TECHNICAL SERVICE BULLETIN

1-D-3

MAINSHAFT THRUST WASHERS

GT6+ & SPITFIRE MARK III

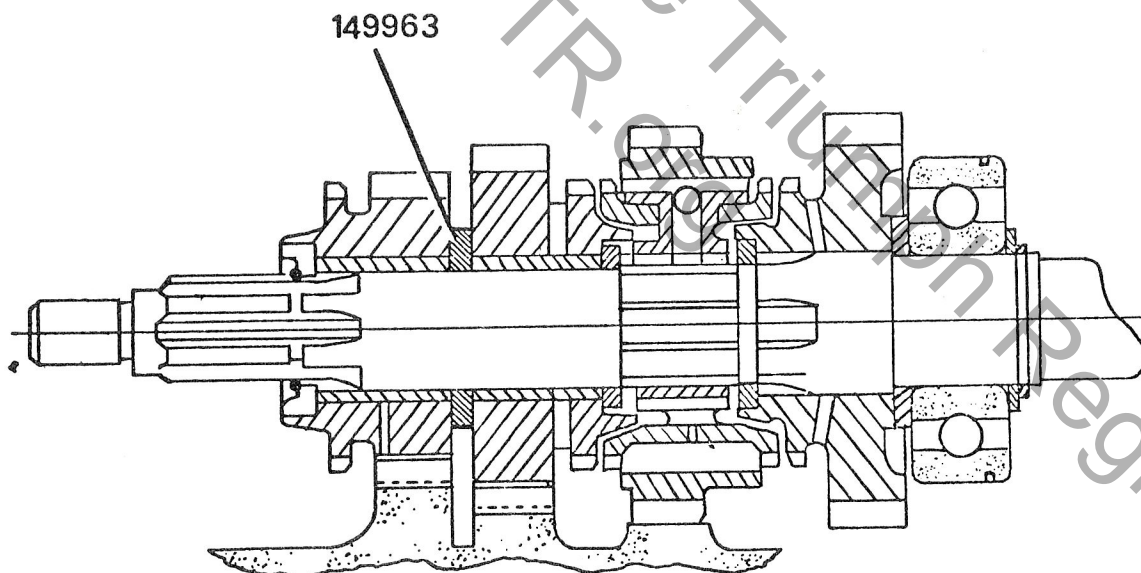
To provide greater scope when adjusting the end float of mainshaft gears on the Spitfire Mark III and GT6+, an additional thrust washer 149963 has been introduced.

The range of 2nd and 3rd mainshaft gear thrust washers is now:

111422	-	Thin
131843	-	Thick
149963	-	Intermediate
